Response to Further Technical Queries on the Basement Impact Assessment and Desktop Ground Movement Assessment

April 2021

Moorfields
Eye Hospital
NHS Foundation Trust

Table 1 Responses to Campbell Reith's Comments (30th March 2021)

SHEET TITLE
 TREE PROTECTION PLAN

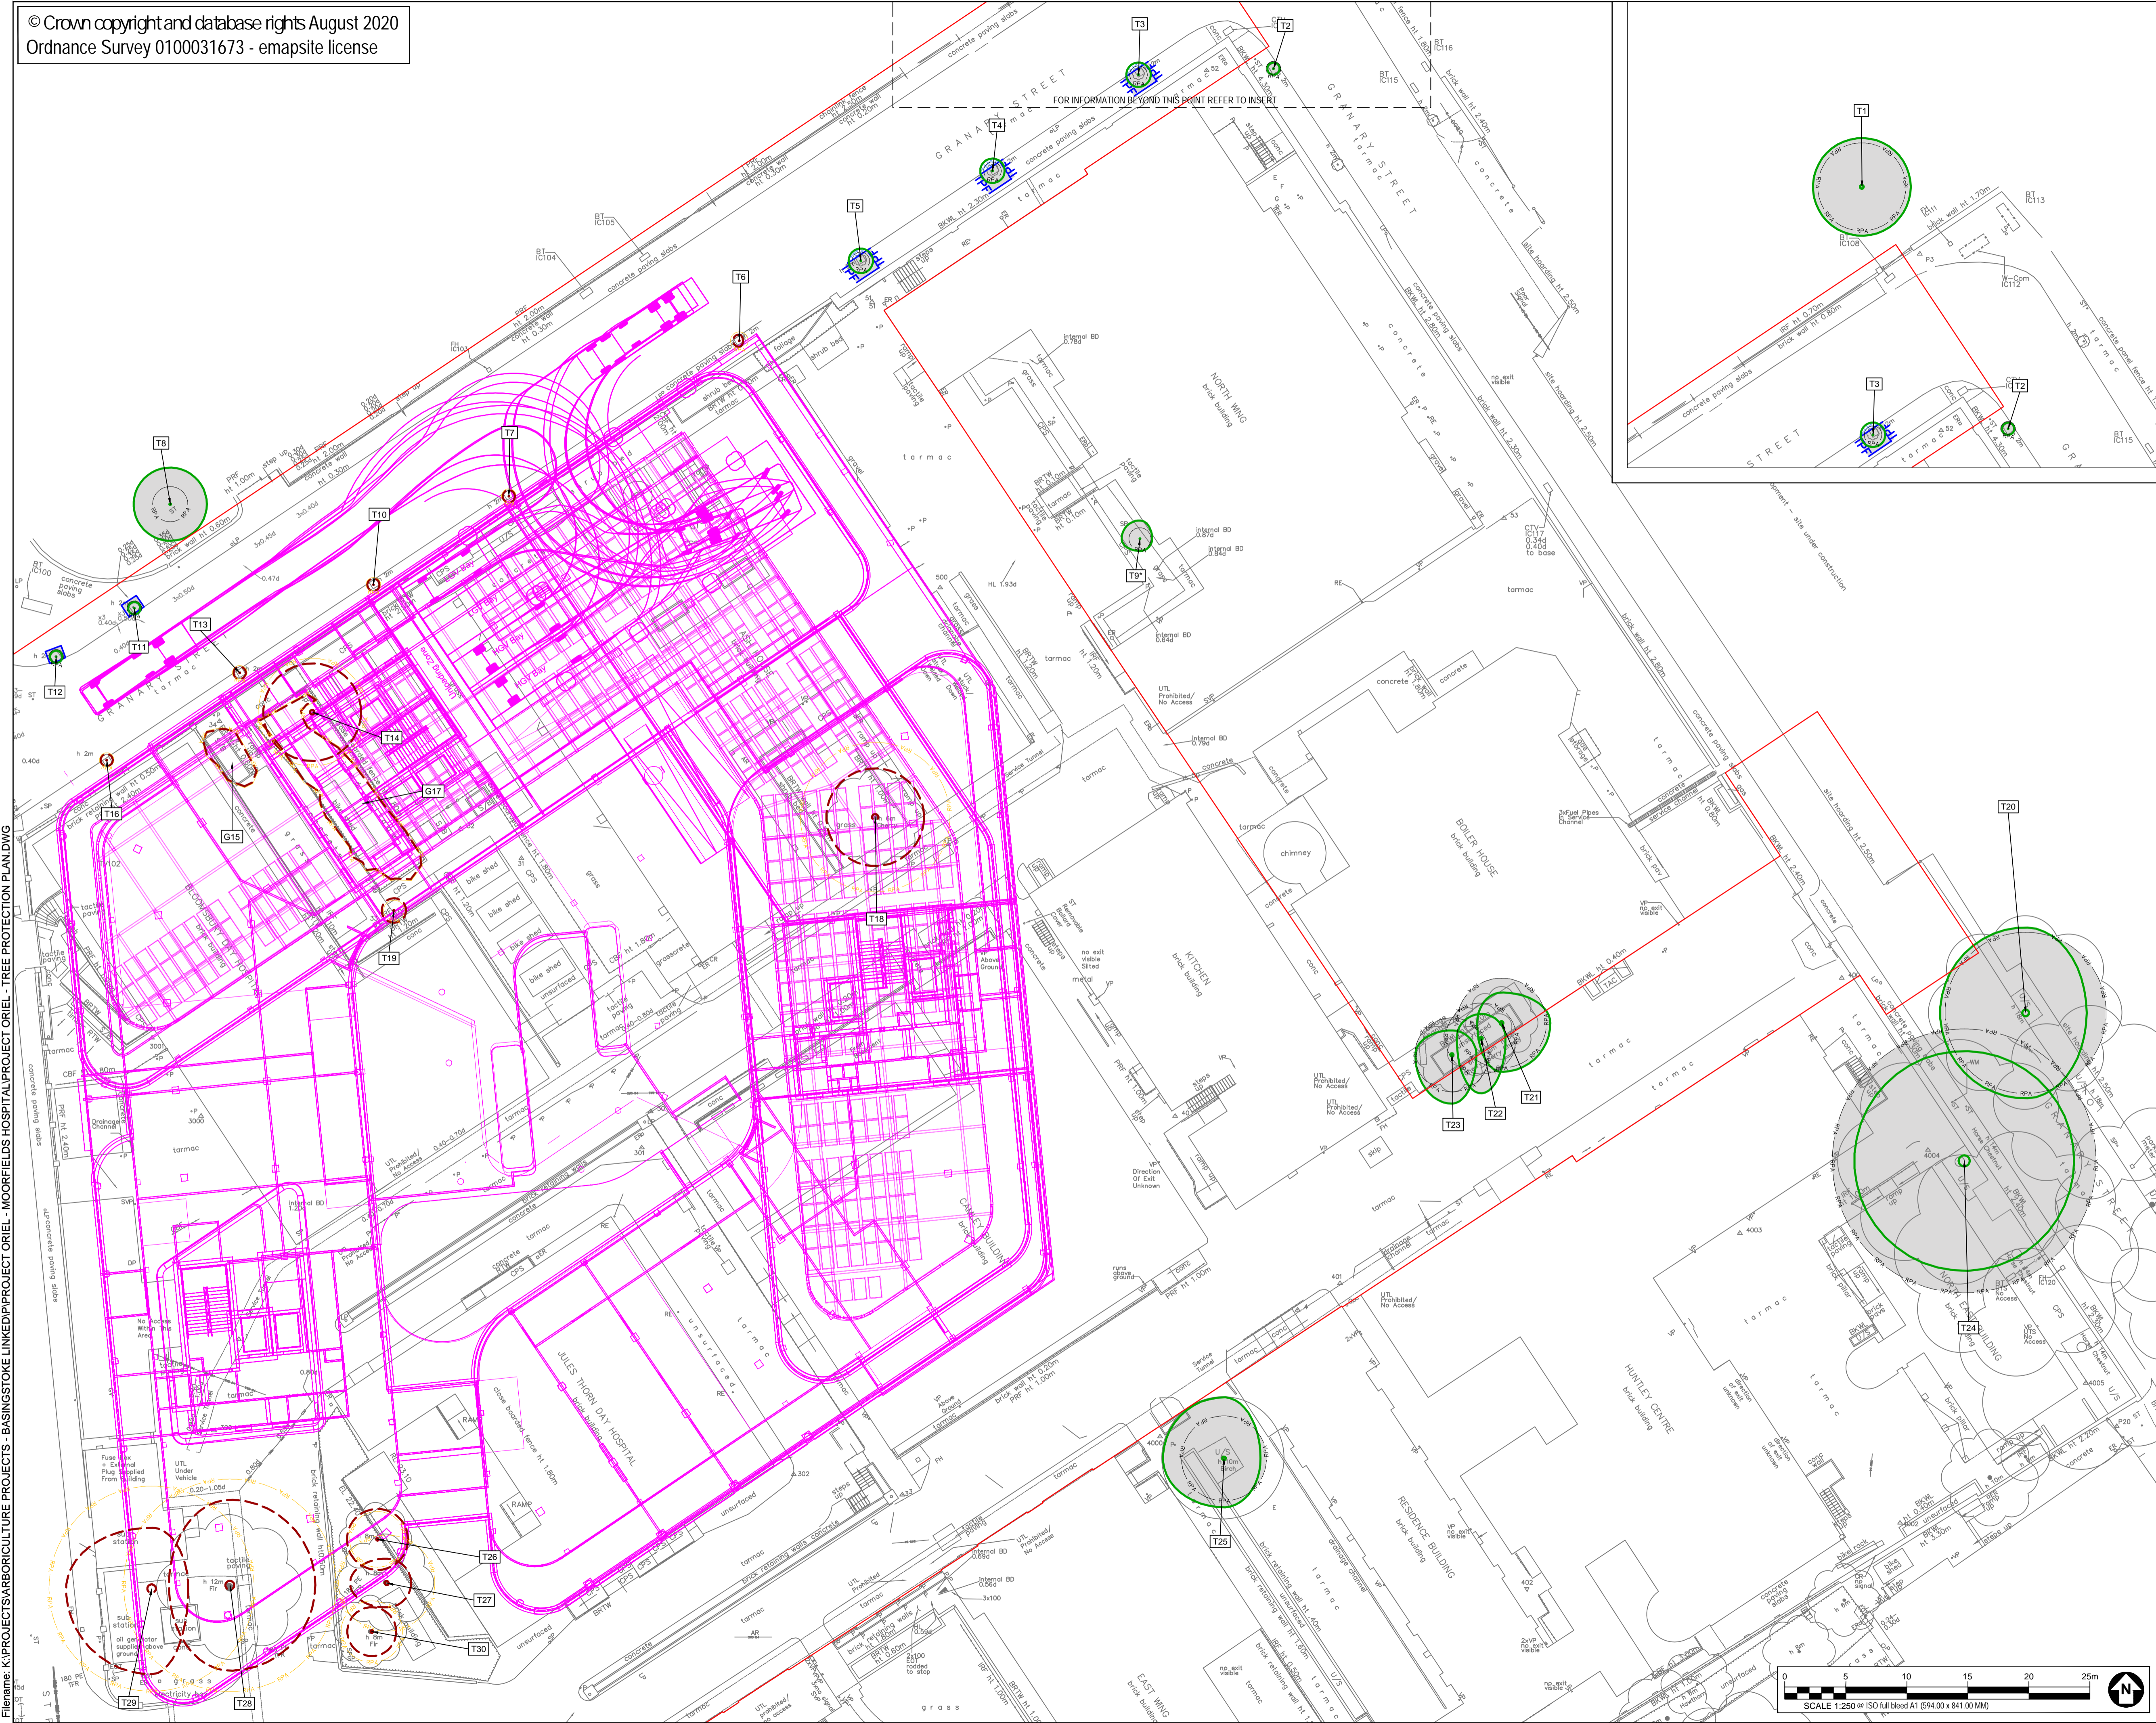
3.	The potential swell impact to adjacent foundations of existing buildings due to the proposed removal of the trees needs to be assessed. More specifically, the proposed removal of T14, T28 & T29 shall be assessed with regard to the foundations of adjacent buildings and mitigation measures provided as might be needed.	<p>All buildings within the direct vicinity of T14, T28 and T29 are to be demolished within the same sequence of works as the tree removal therefore potential ground swell will not take place within the time frame between the tree removal and building demolition. Remaining structures on the opposite side of the carriageway are anticipated to utilise deep piled foundations which are unlikely to be affected by the removal of trees. Please refer to the tree protection plan (originally included in the Arboricultural Impact Assessment (Document Ref. ORL-INF-XX-XX-RP-PL-130)) reproduced in Appendix A of this document, for information on the location of trees.</p> <p>It is proposed that the impact of tree removals on adjacent foundations is verified at the detailed design stage following results of the Phase 2 Ground Investigation and final demolition and tree removal methodology, forming part of the Basement Construction Plan. Table 6 and Table 7 within the BIA have been updated to reflect this.</p>
